Notice of Intent

Sundry ID: 2754851

Type of Action: APD Change

Procedure Description: Mewbourne Oil Company request a variance to perform break testing and offline cementing on the following wells: Querecho 23/26 Fed Com 523H Querecho 23/26 Fed Com 616H Night Watch 2/1 Fed Com 511H Night Watch 2/1 Fed Com 513H Gemini 36/35 Fed Com 513H Gemini 36/35 Fed Com 516H Corona 25/26 Fed Com 525H Corona 25/26 Fed Com 528H Pavo Macho 31/33 Fed Com 616H Pavo Macho 31/33 Fed Com 618H

Figure 1. Cactus 13 3/8" 5M offline cementing tool. Pressure rating limited by the lesser of 5M tool rating or the 13 3/8" pup joint and casing.

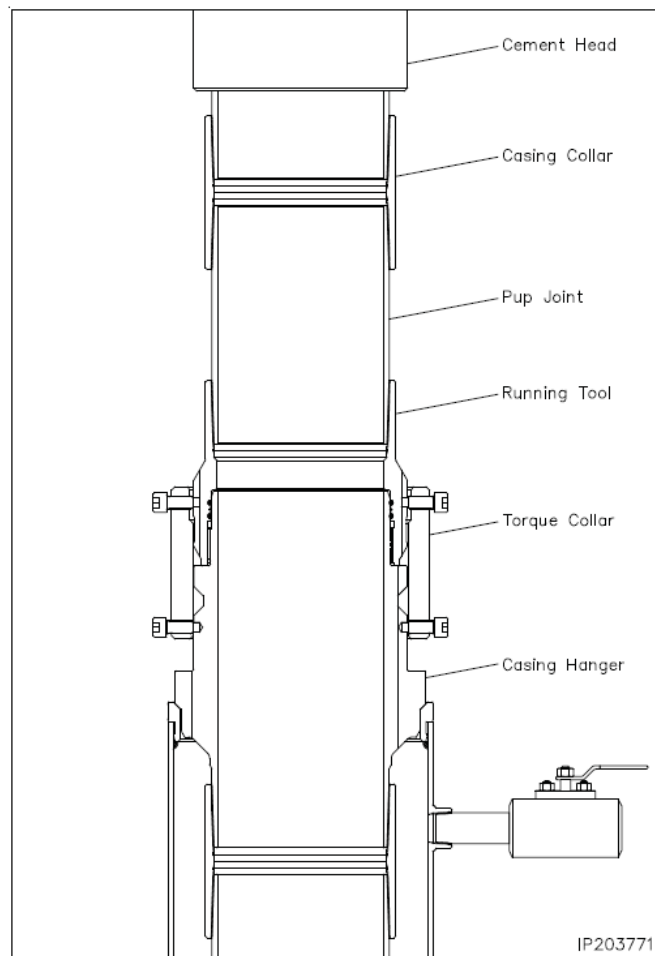
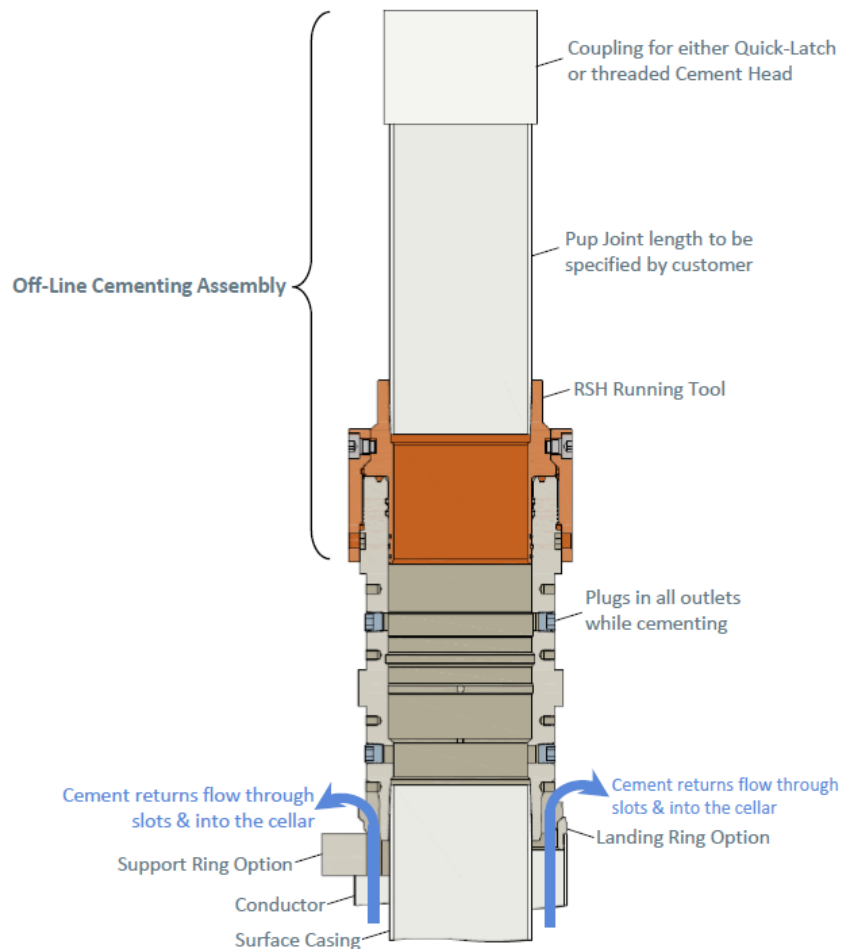
9. Make up offline cement tool with forklift per wellhead manufacturer (Fig. 1 & 2).
10. Make up cement head on top of offline cement tool with forklift.

Offline cementing variance is approved for surface and intermediate casings only. Contact the BLM prior to the commencement of any offline cementing procedure.

Figure 3. Cactus 9 5/8" 5M offline cementing tool. Pressure rating limited by the lesser of 5M tool rating or the 9 5/8" pup joint and casing.

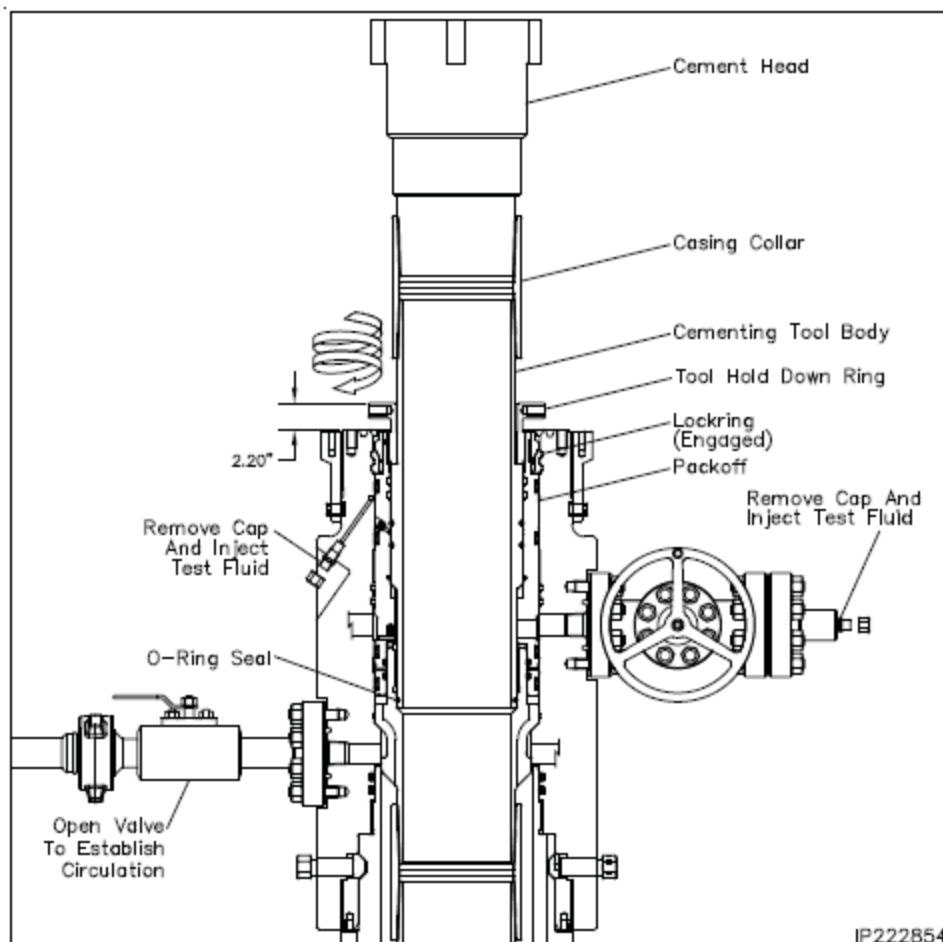
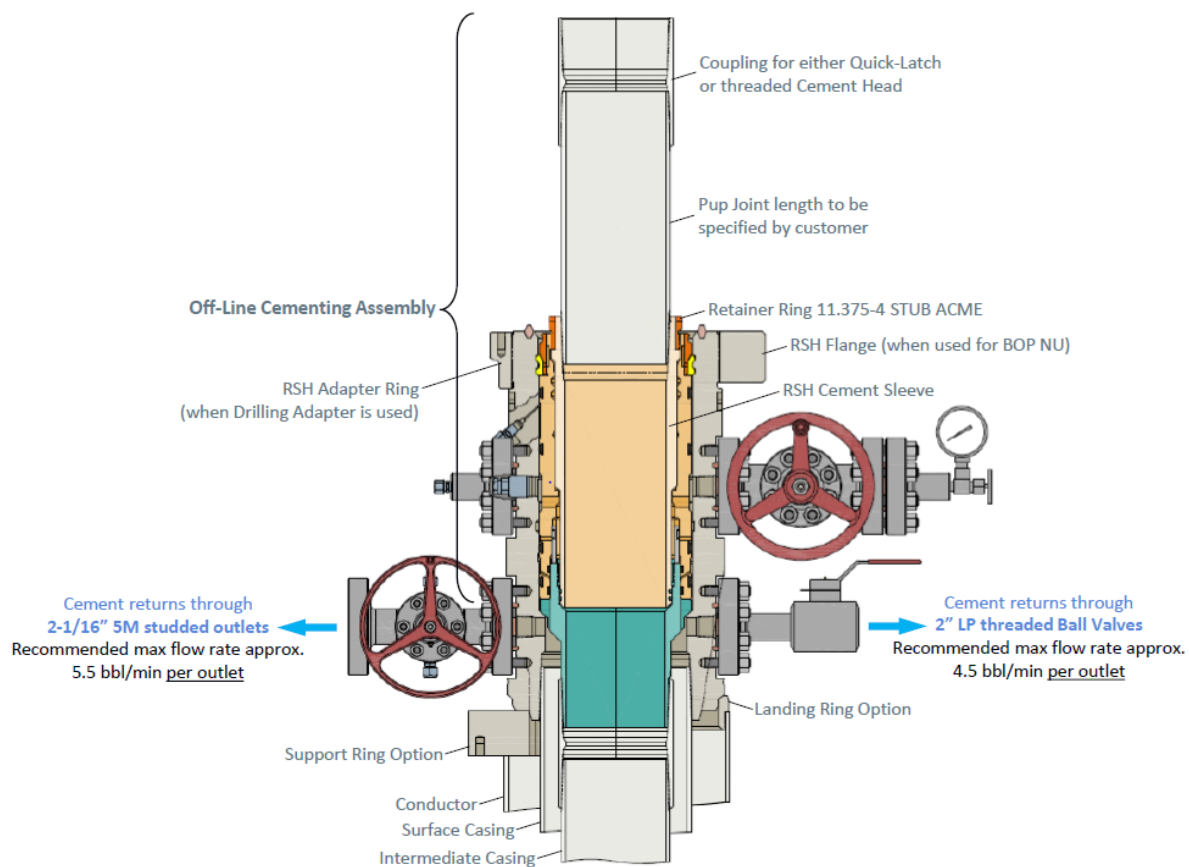
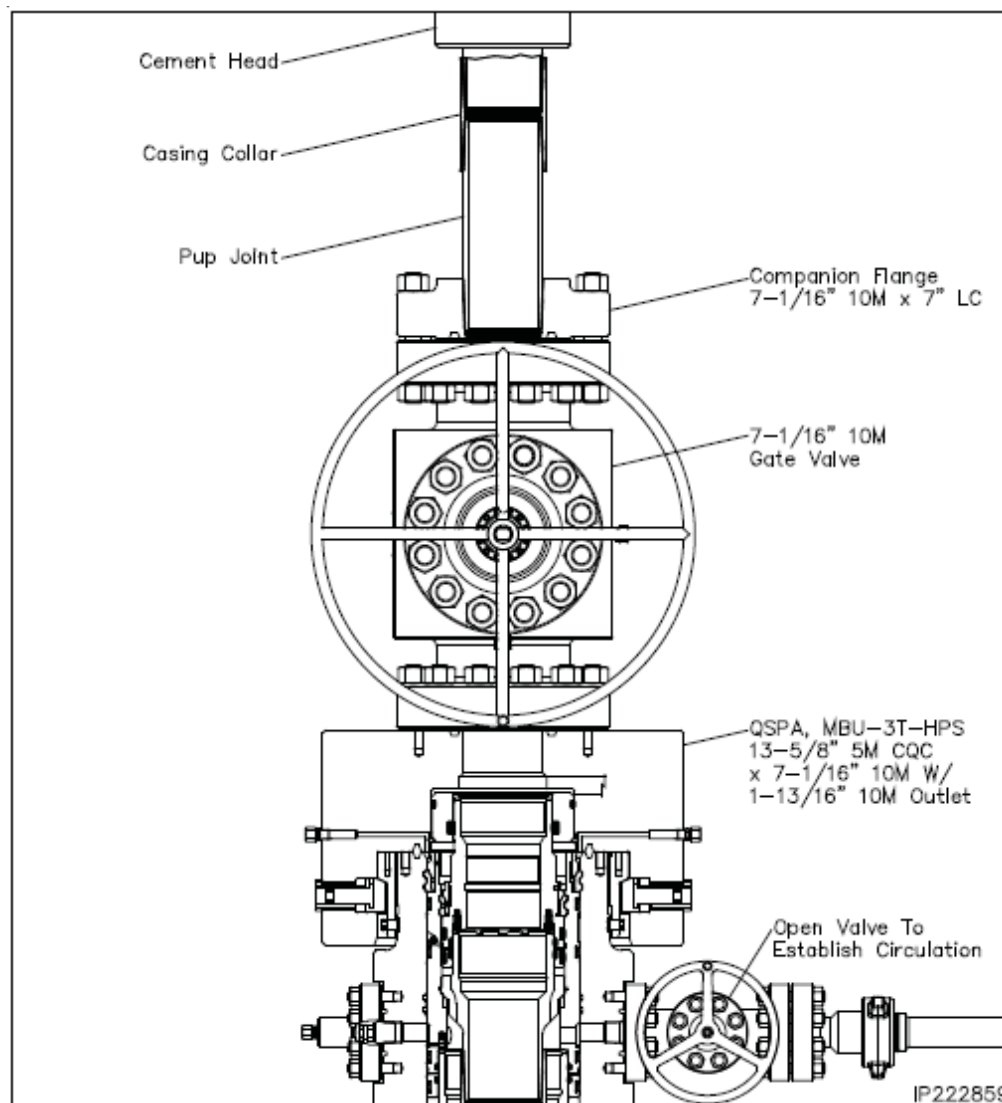
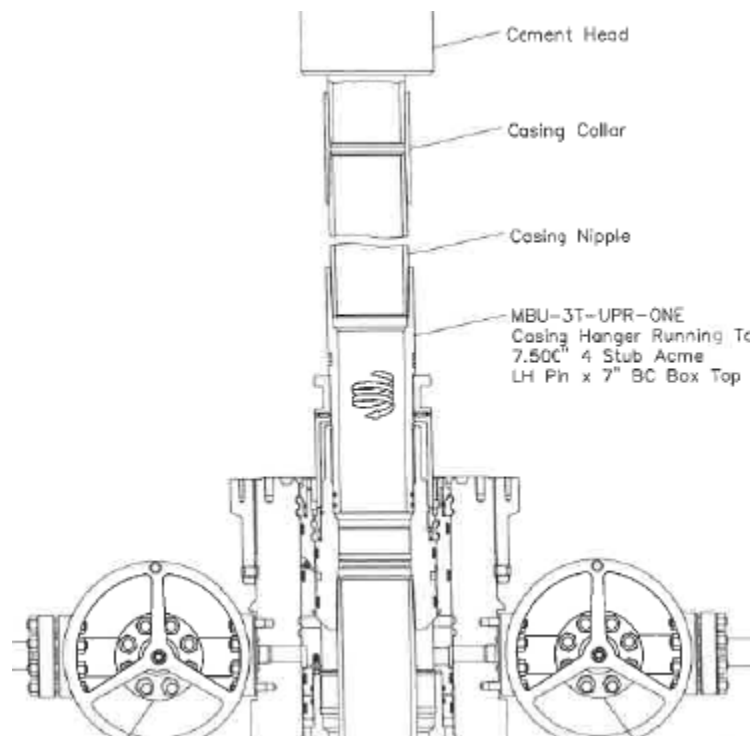
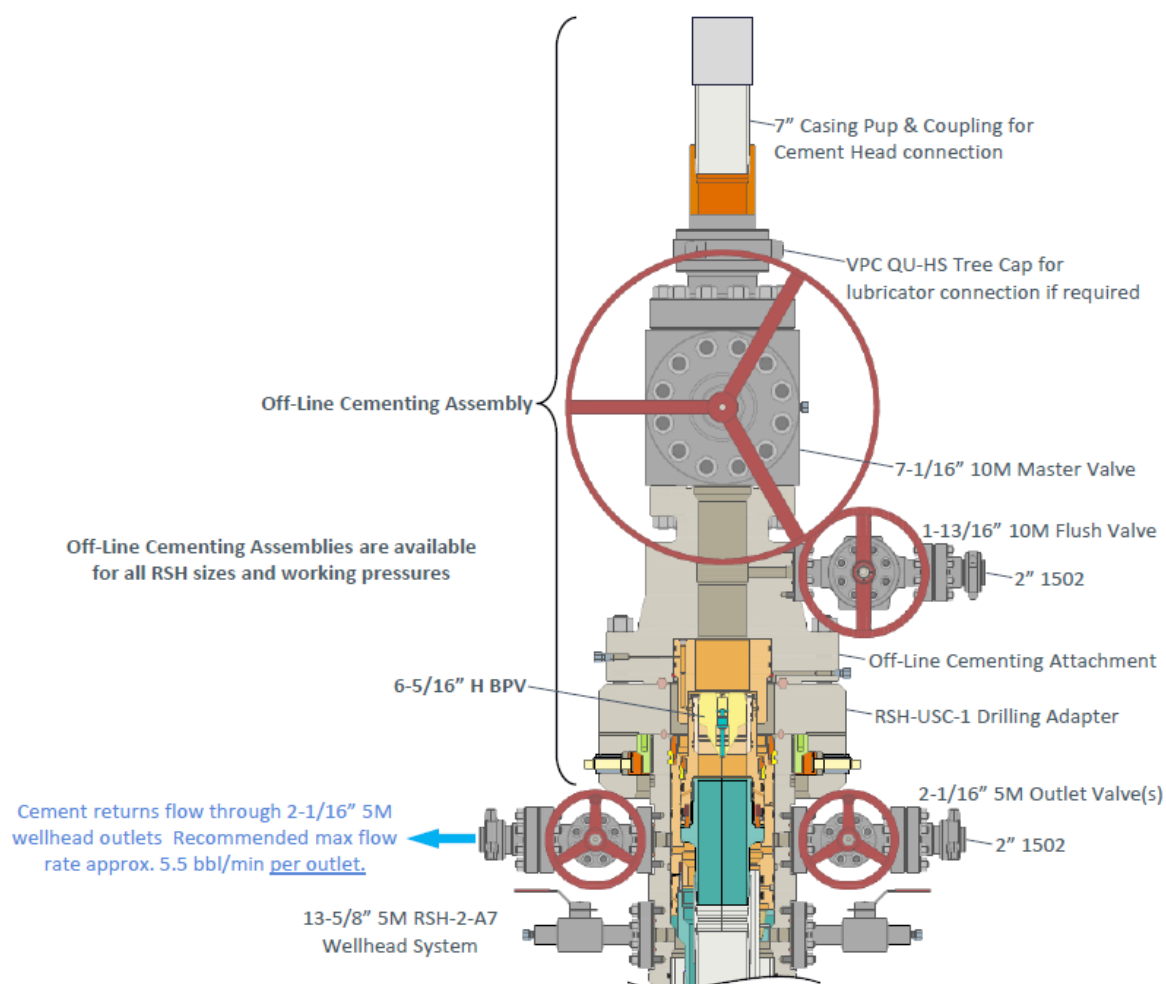
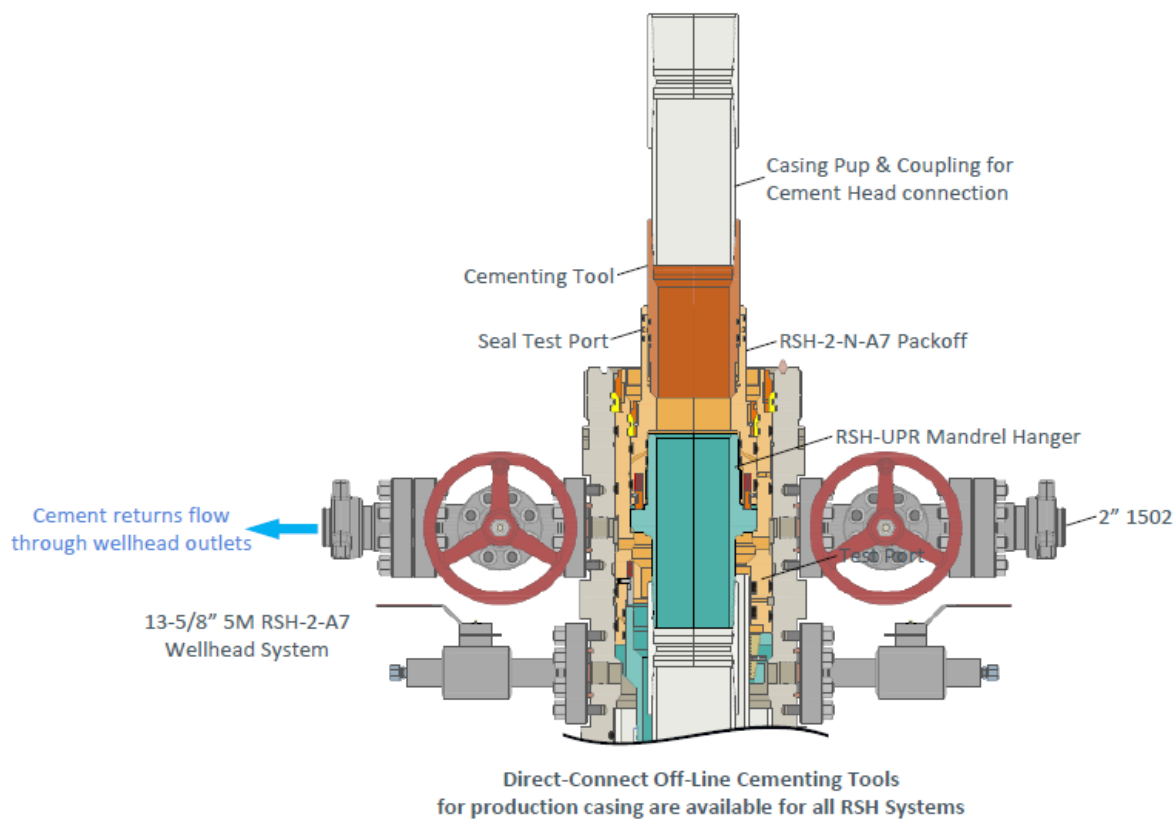
10. Make up offline cement tool using forklift per wellhead manufacturer (Fig. 3 - 8).
11. Make up cement head on top of offline cement tool.
12. Commence cement operations.

Figure 1. BOP diagram

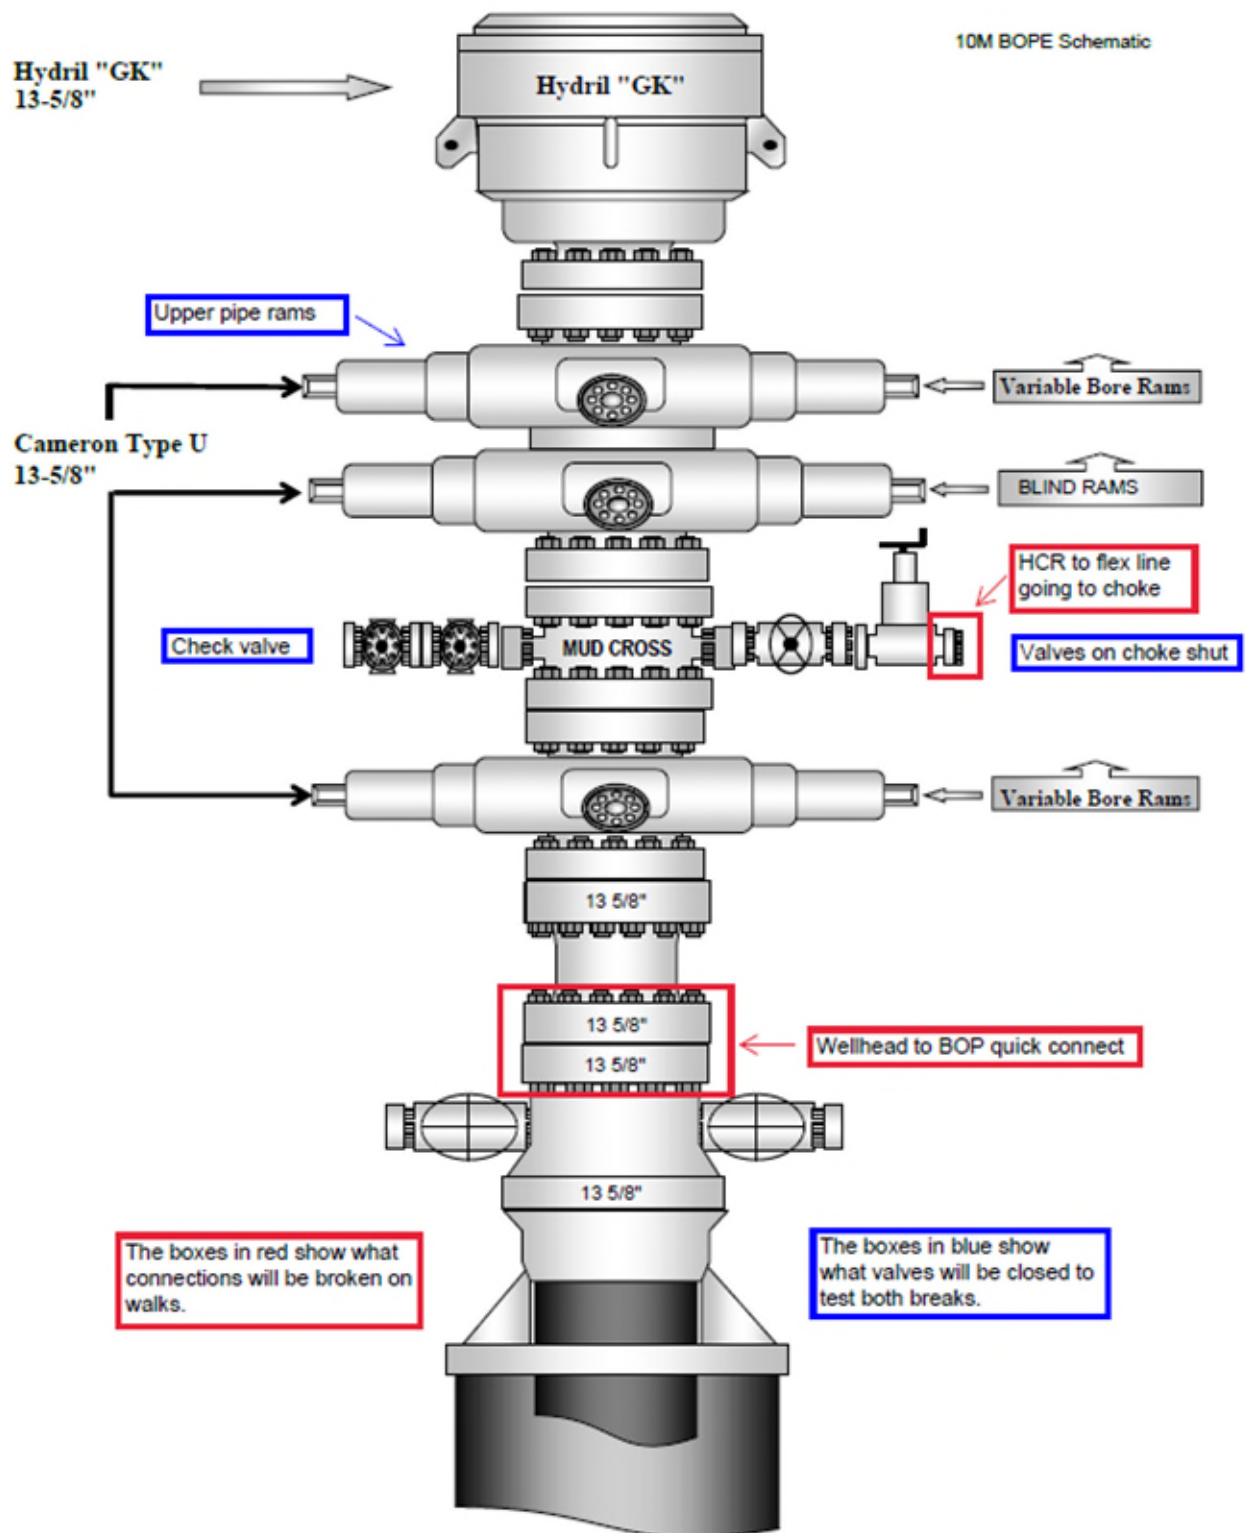
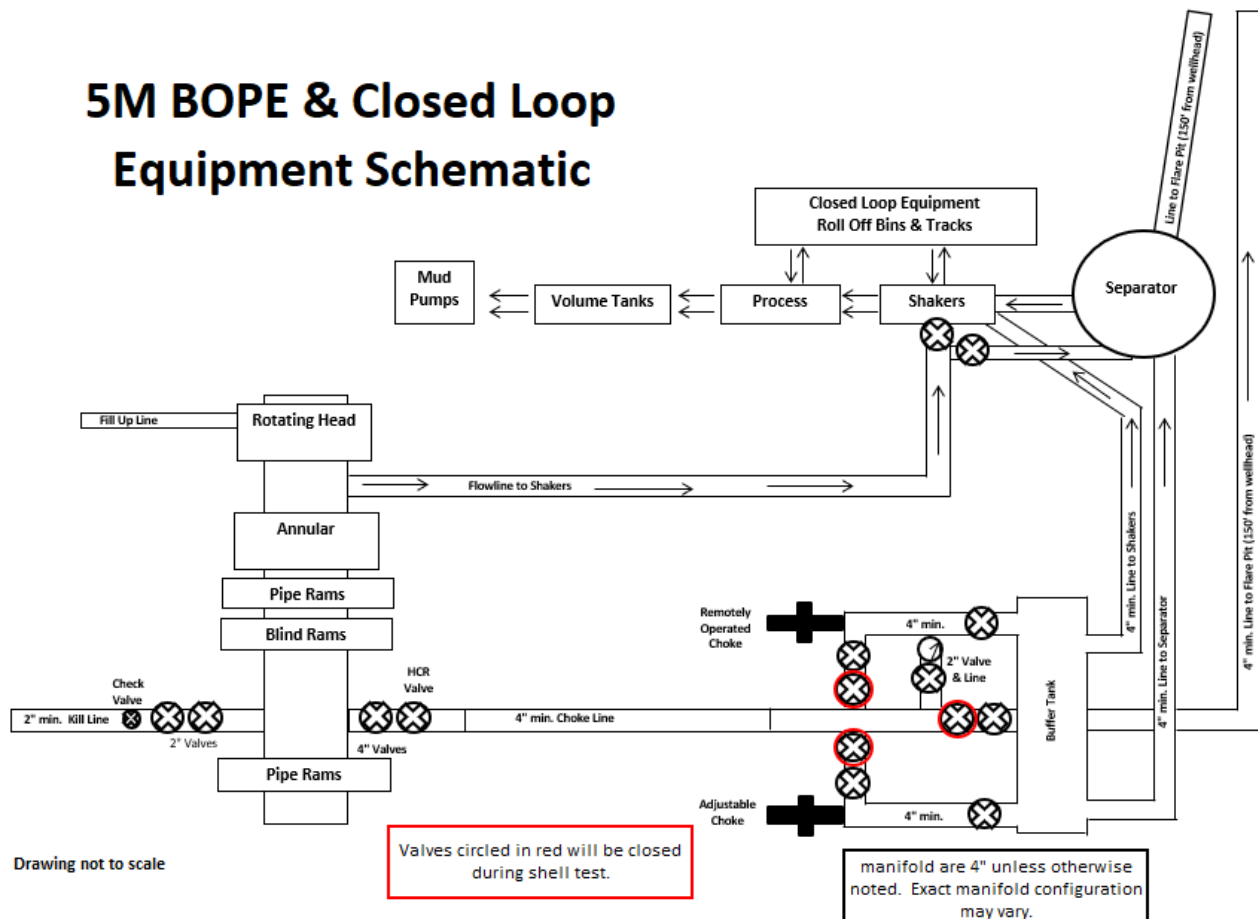
2. After the well section is secured and the well is confirmed to be static, the BOP will be disconnected from the wellhead and walked with the rig to another well on the pad. Two breaks on the BOPE will be made (Fig. 1).

9. A test will then be conducted against the upper pipe rams and choke, testing both breaks (Fig. 1 & 2).
10. The test will be held at 250 psi low and to the high value submitted in the APD, not to exceed 5000 psi.

- BOPE Break Testing is ONLY permitted for 5M BOPE or less. (Annular preventer must be tested to a minimum of 70% of BOPE working pressure and shall be higher than the MASP)

- BOPE Break Testing is NOT permitted to drilling the production hole section.
- Variance only pertains to the intermediate hole-sections and no deeper than the Bone Springs formation.
